Re: Townhouses on 32-34 Washington Avenue
Revised Documents for review by the Planning Board

Summary of Response to Planning Board Comments 5-21-15

Summary of Response to Planning Board Comments 7-1-15

S-1

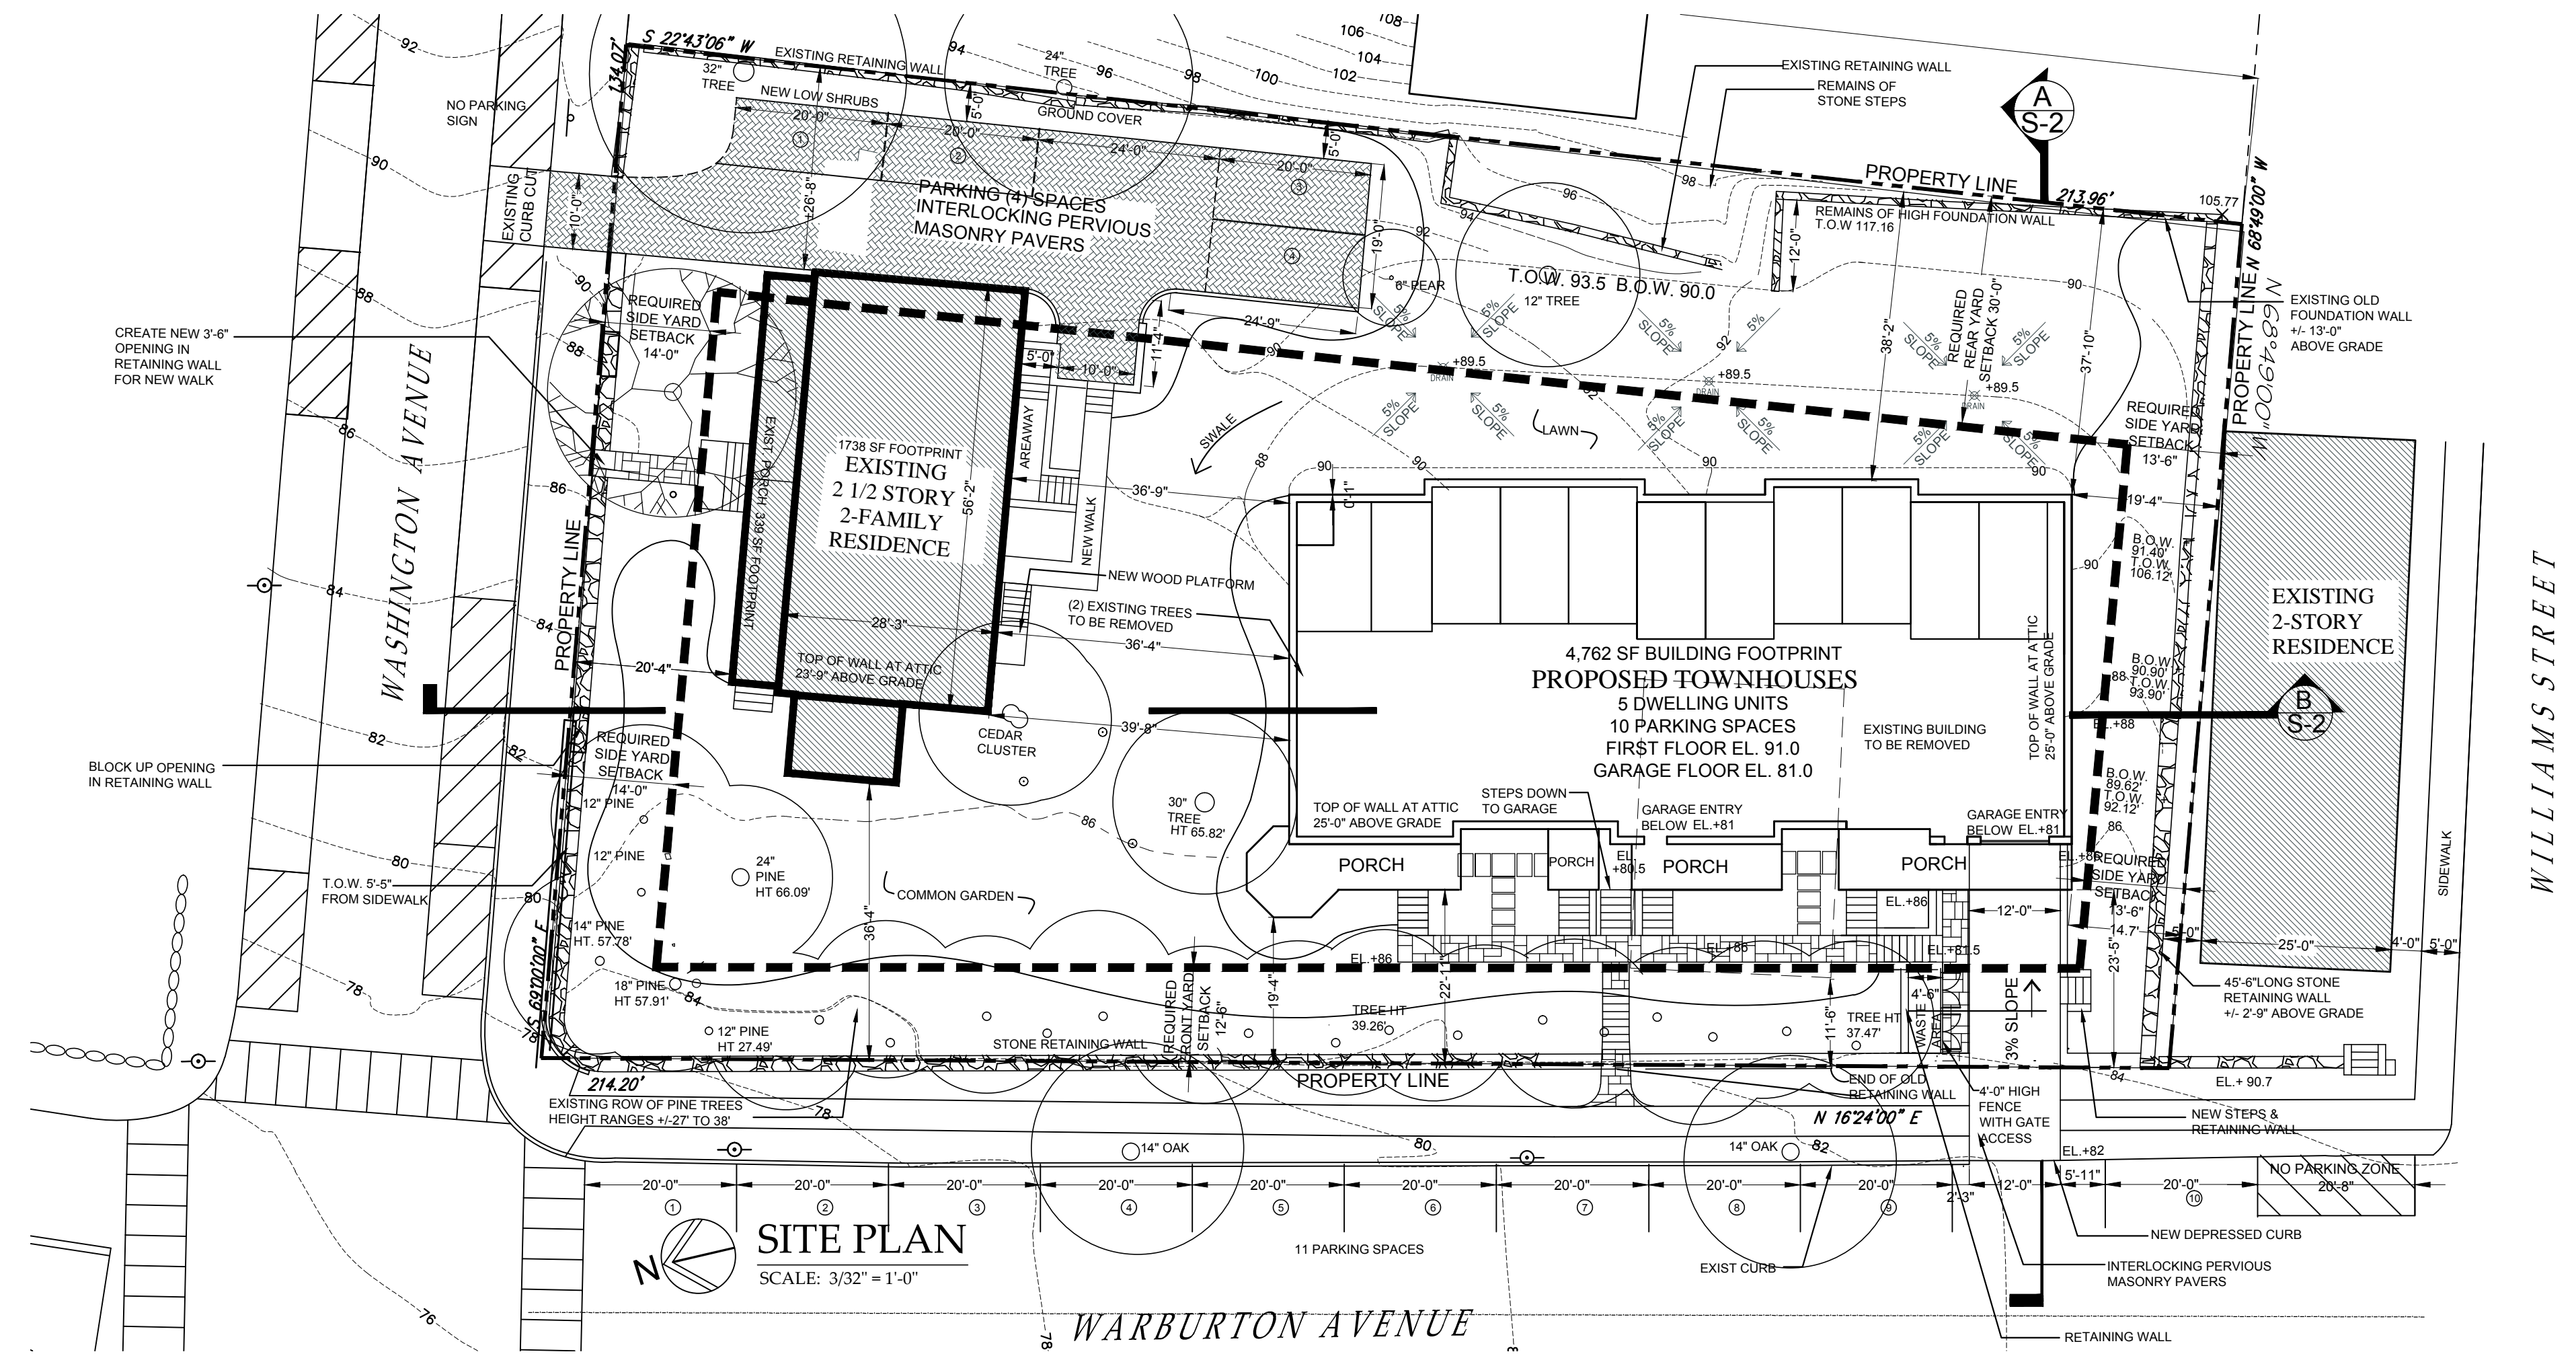
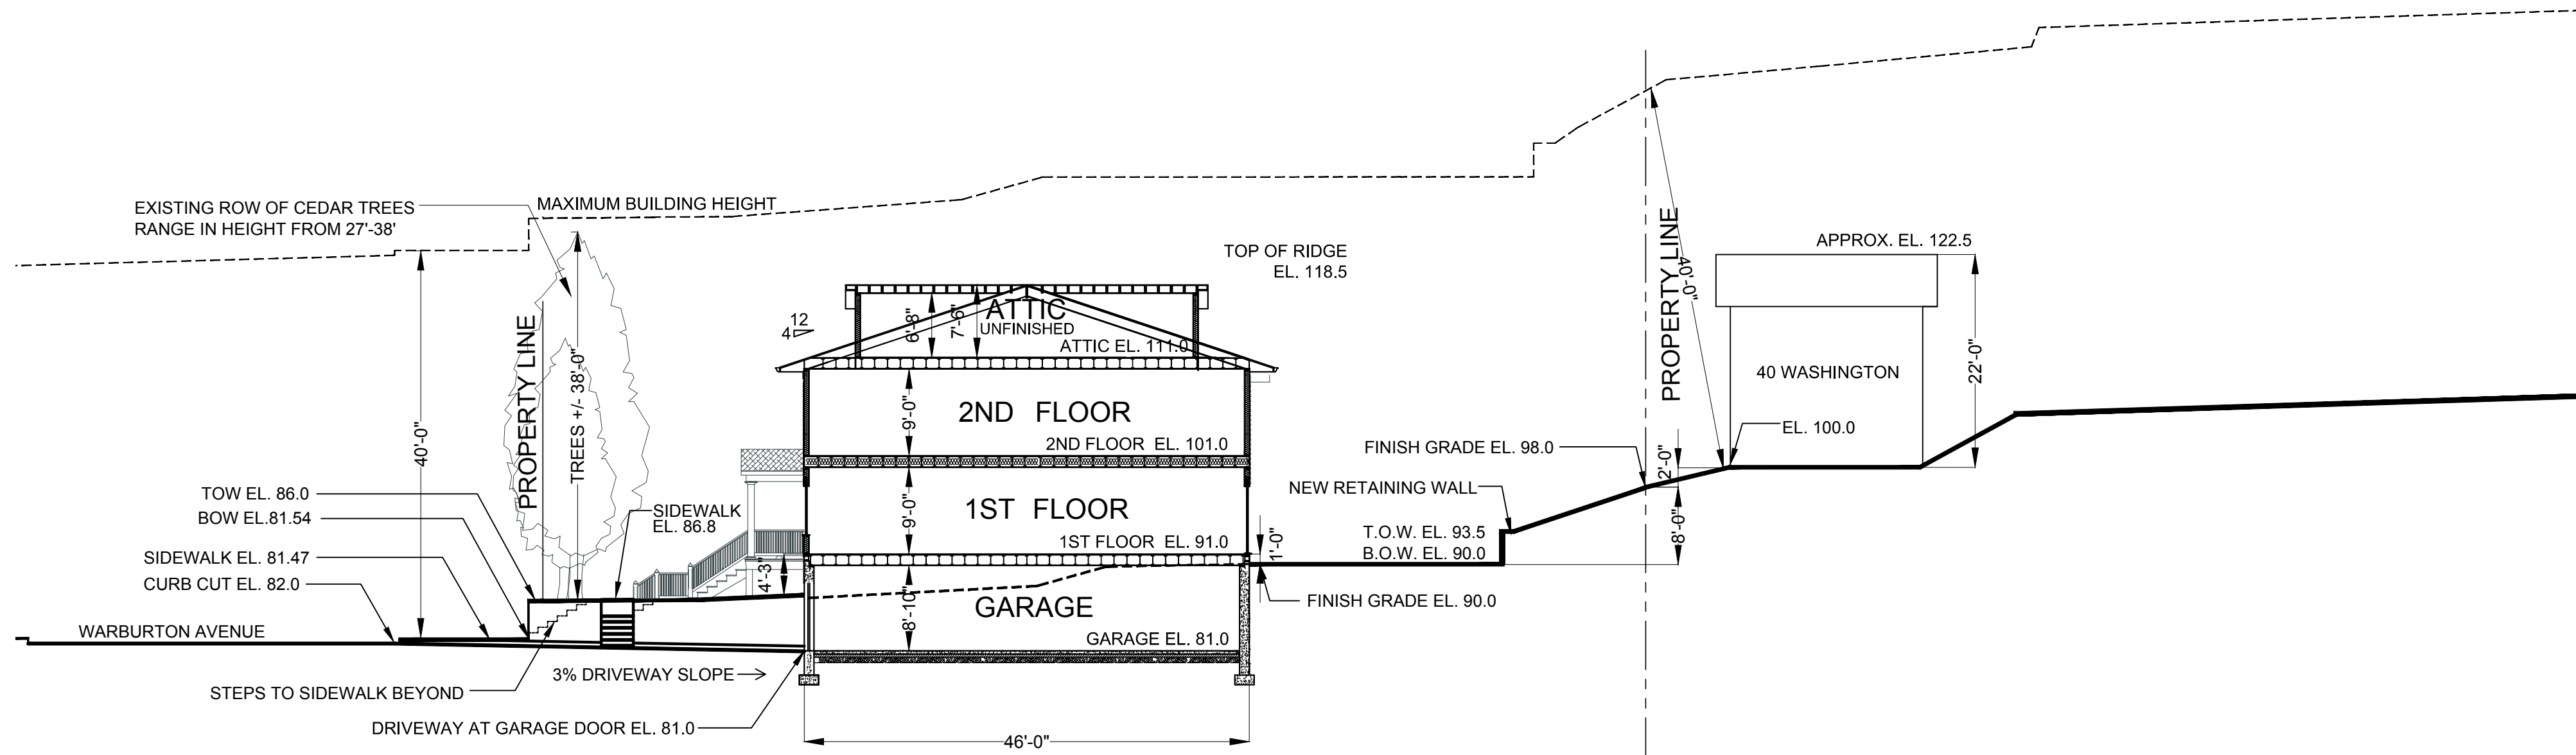
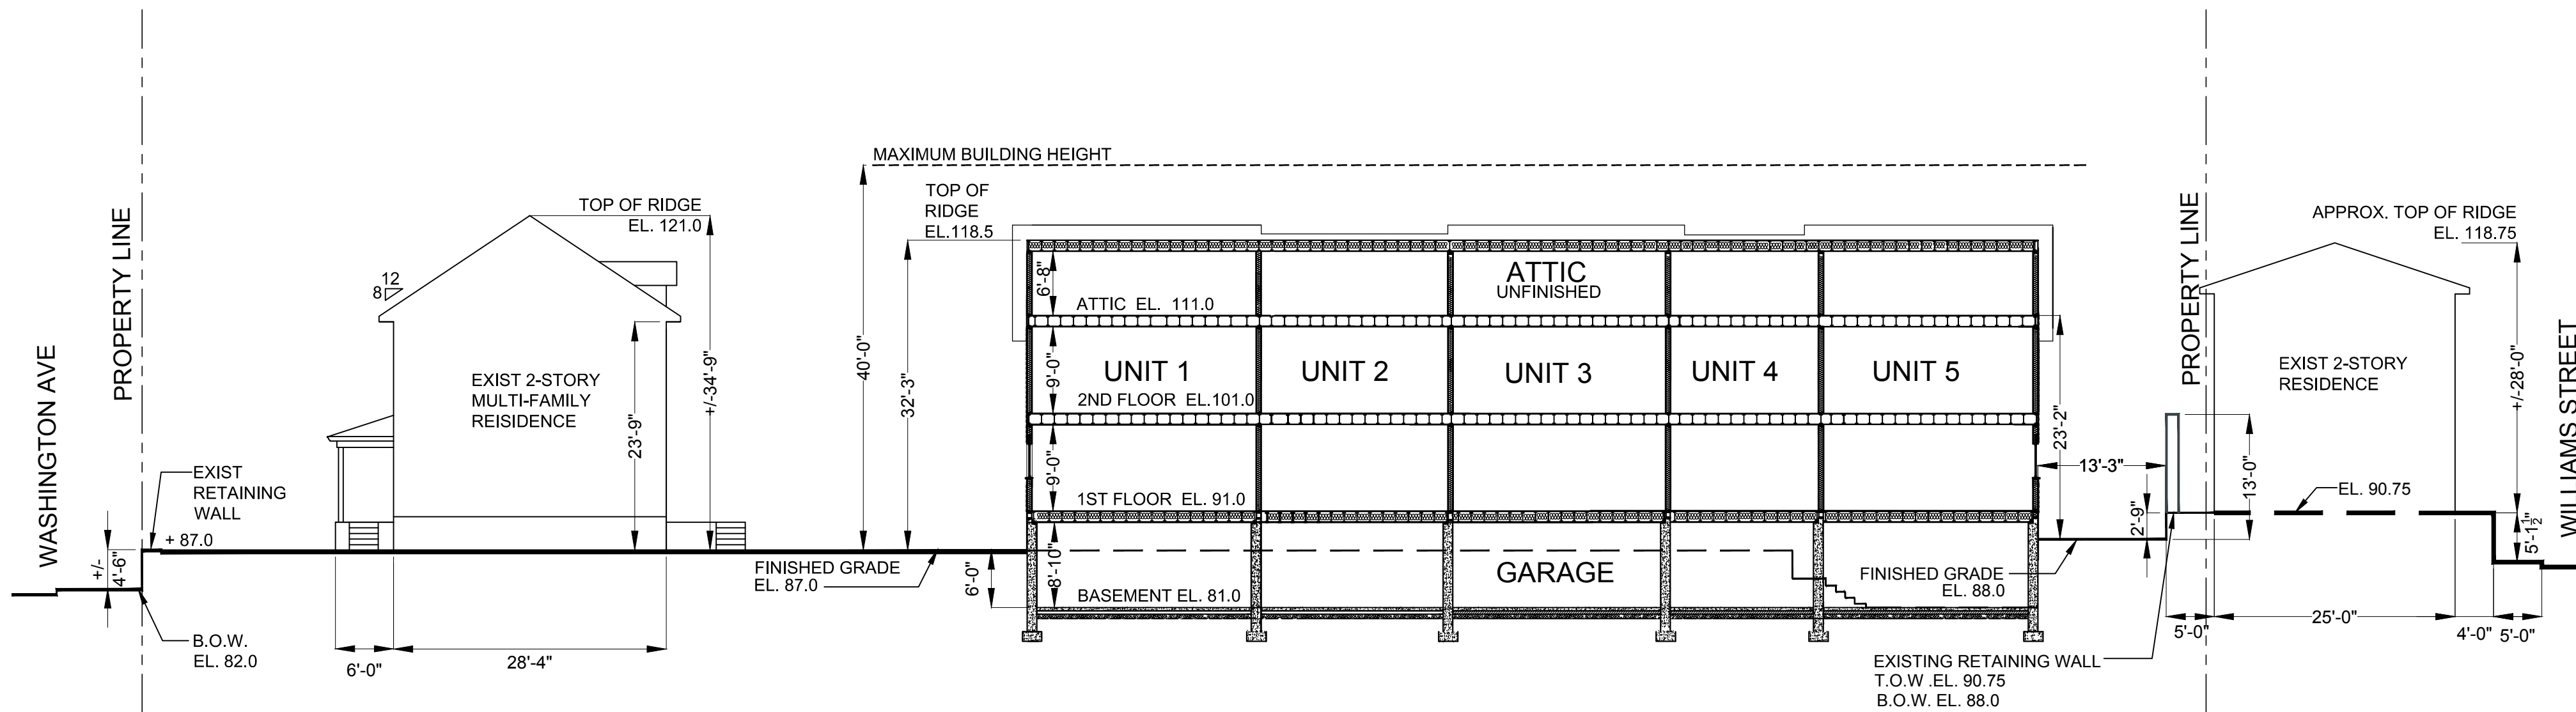
3. Letter from landscape architect, Stephen Lopez, dated 7-1-15, about impact on trees by construction provided. Note that the recommended safe distance of 15 feet from the trees to the building has been provided, see Site Plan drawing S-1, dated 6-30-15

4. Central exterior stair to provide pedestrian access from Warburton Avenue has been added back to the plans, see drawings S-1, C-1, C-2, C-3, dated 6-30-15. As a result, the development coverage changed from 39% to 40%, see revised zoning data, drawing S-1, and revised density studies, drawings S-3 and S-4, dated 6-30-15.
